SUBJECT: Michigan Department of Environmental Quality Comments for OU5
[Operable Unit 5] Allied Paper, Inc./Portage Creek/Kalamazoo River
Superfund Site, Area 2 Draft Feasibility Study, Revision 1, dated
October 31, 2016, Prepared by Amec Foster Wheeler, Environment &
Infrastructure, Inc.

Document:	Kalamazoo Area 2 Revised FS			
Comment Author:	MDEQ			
Comment #	Page	Section and paragraph	If applicable, specific quotation from text	Comment
General Comments				
1	---	---	---	MDEQ would like to receive red-line versions of revised reports in the future.
2	---	---	---	The report should indicate that bank materials are separate and unique between floodplain and instream sediments. Criteria for bank material have not been developed, and it is clear that preventing bank material erosion is key to achieving our goals. As such, the future remedy will need to result in effective separation of the bank material from the aquatic/instream system. Uncertainties regarding the effectiveness of the proposed remedies, in achieving this goal, exist. The future success of the proposed remedies can only be confirmed through an adequate and robust Long-Term Monitoring (LTM) program.
Specific Comments

Figure
2.1-2

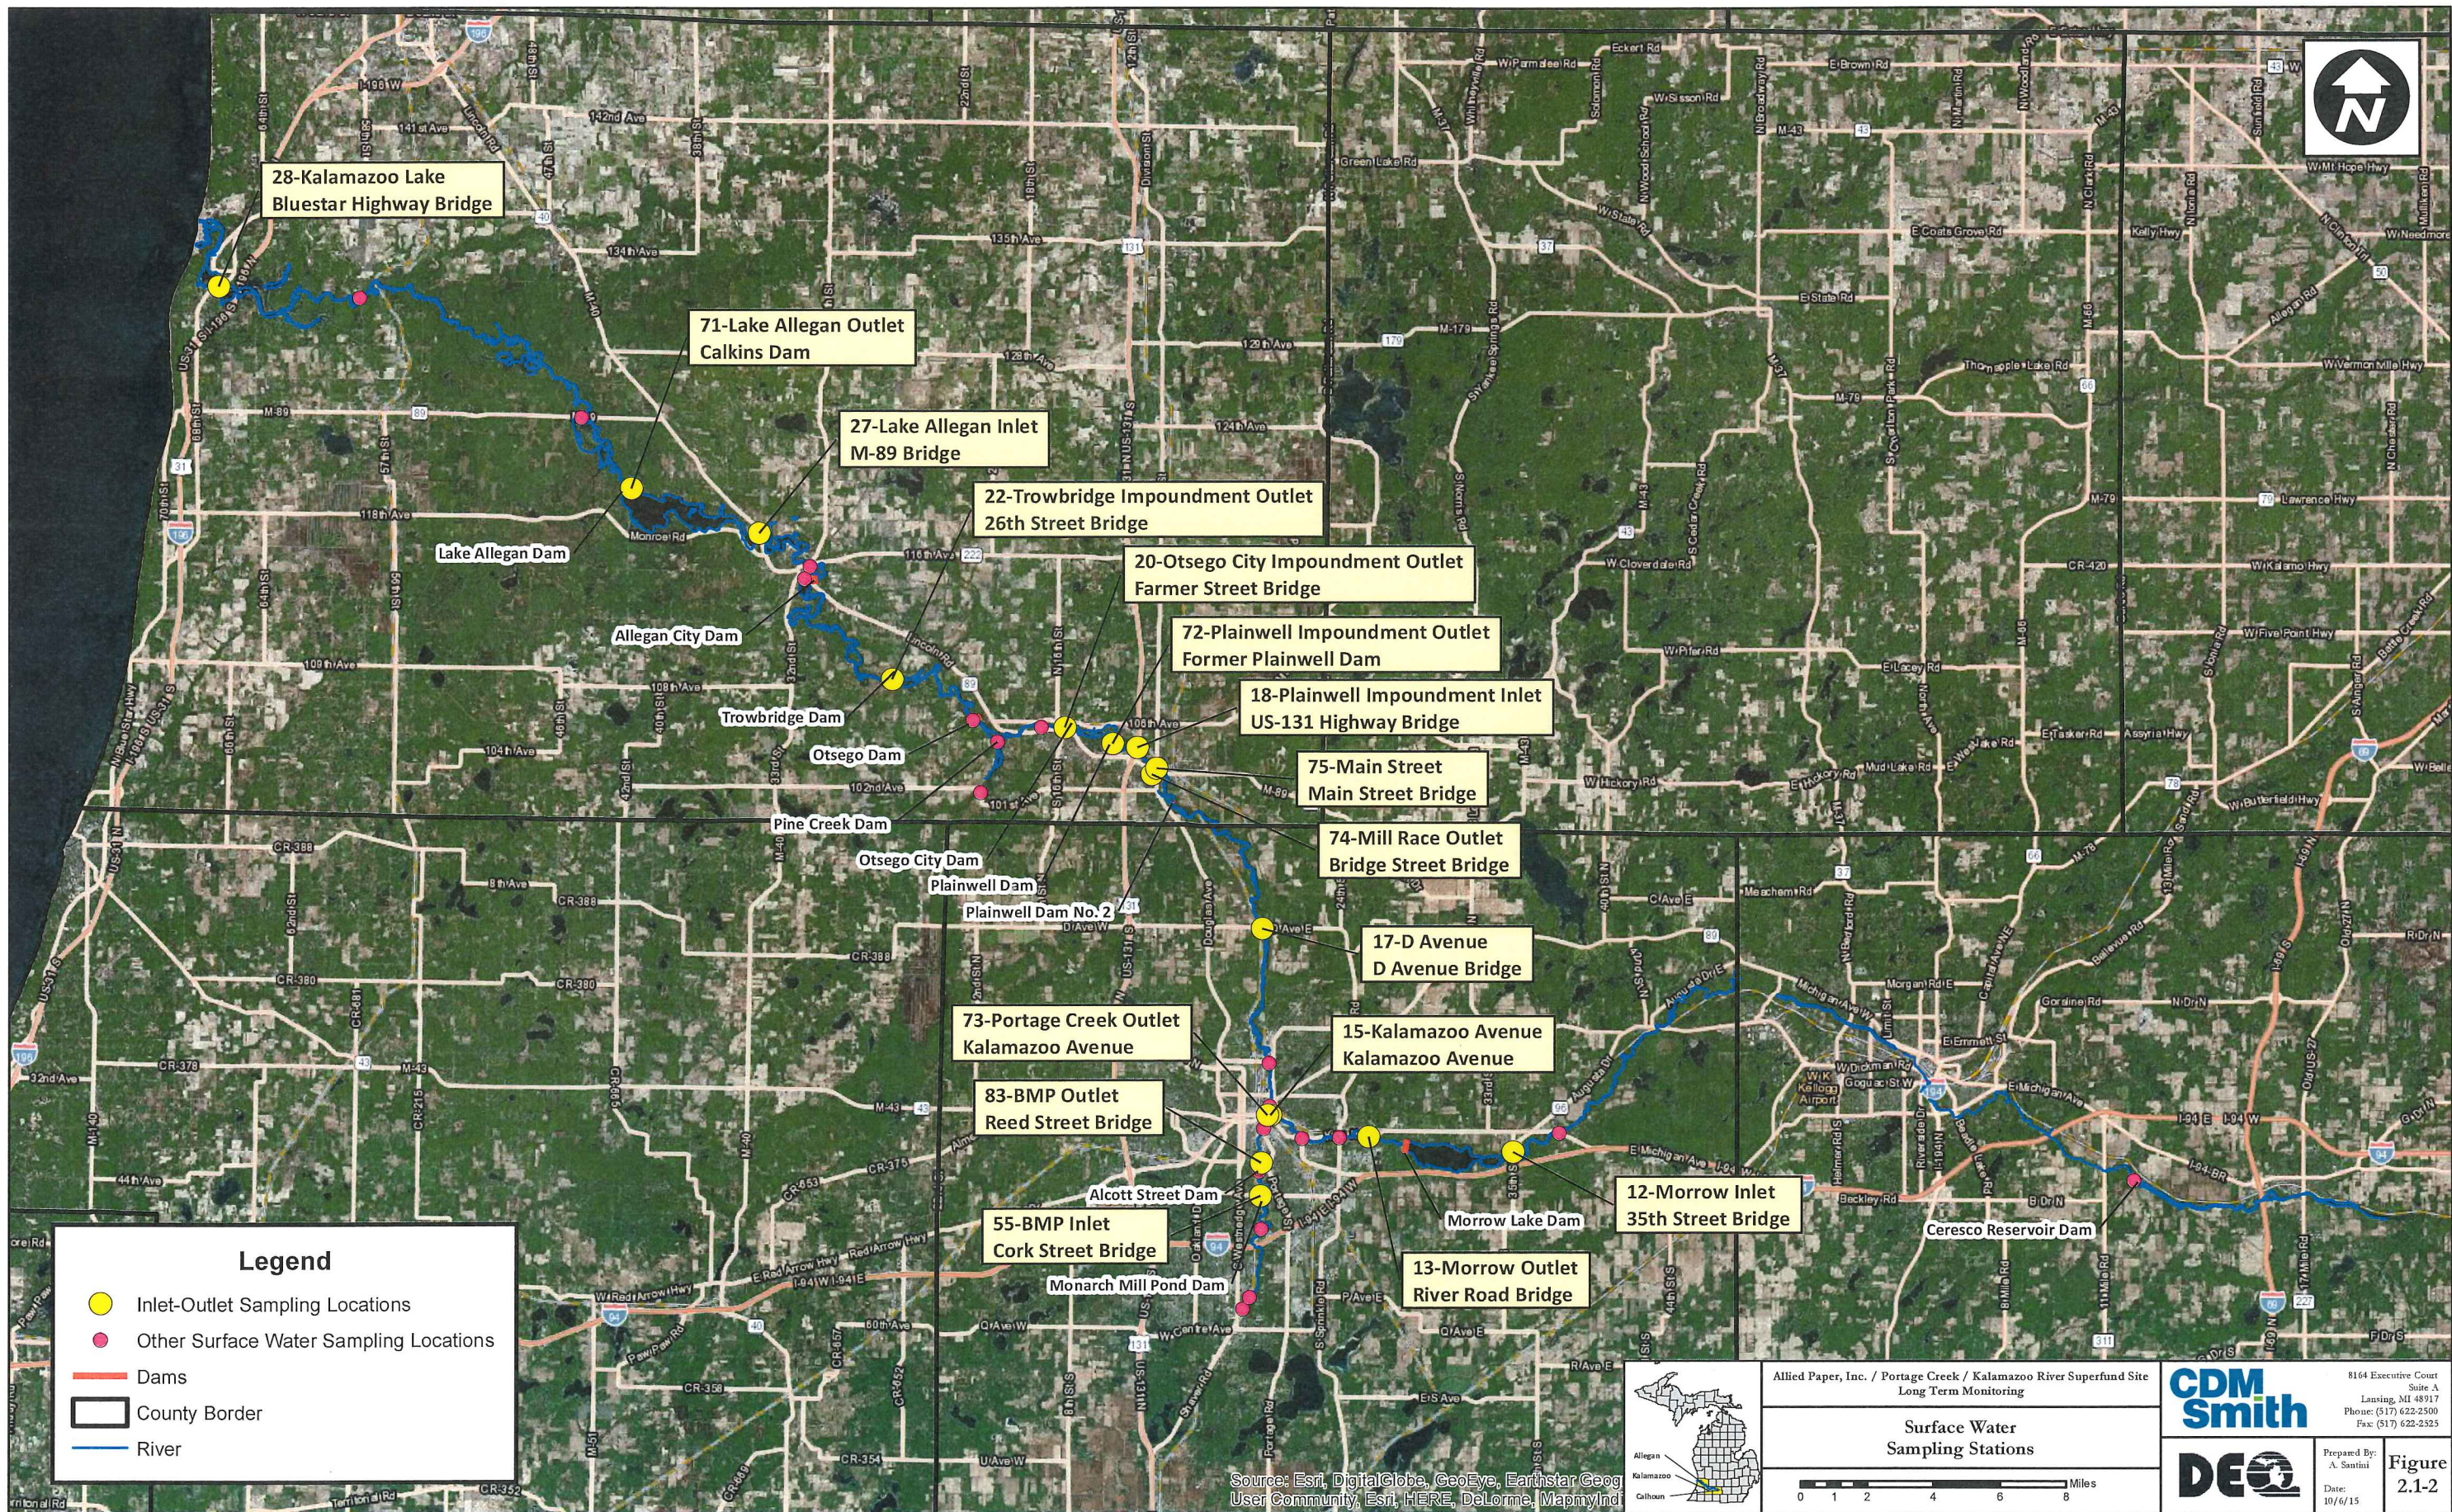
7	ES-20	A-3: Capping, Channel Realignment, Gun River Excavation, Targeted Excavation on Knife Blade Island, ICs, and LTM	Cap soil is assumed to mostly consist of clean cut material recovered from the channel realignment.	The report should indicate that clean cut material will be considered for use ONLY if concentrations are below 1 part per million (ppm) using the sampling design developed during the Remedial Design. This same 1 ppm threshold for reusing excavated materials was utilized at the Otsego Township Dam Area Time-Critical Removal Action (TCRA). Revise the text accordingly.
	1-2	1.2 SITE HISTORY	Nonpaper sources of PCBs have also been identified throughout the watershed.	The report should make clear that releases from the mills are responsible for the vast majority of polychlorinated biphenyls (PCBs) within the system. A simple graphic with fish tissue and surface water will help to make the point. See the attached figures from the last MDEQ LTM report.

1-18	1.3.3 Contaminant Fate and Transport	Several factors affect the persistence and migration of PCBs within Area 2. Sources of PCBs in Area 2 are area sediments, eroding bank soils, flows from upstream and tributaries, runoff from adjacent areas, other discharges to the river, and atmospheric sources.	Other sources are small in comparison to internal sources that were released from the paper mills. Such a basic distinction should be made. The attached figures from the MDEQ LTM report are good visual indicators of the magnitude of the other sources.
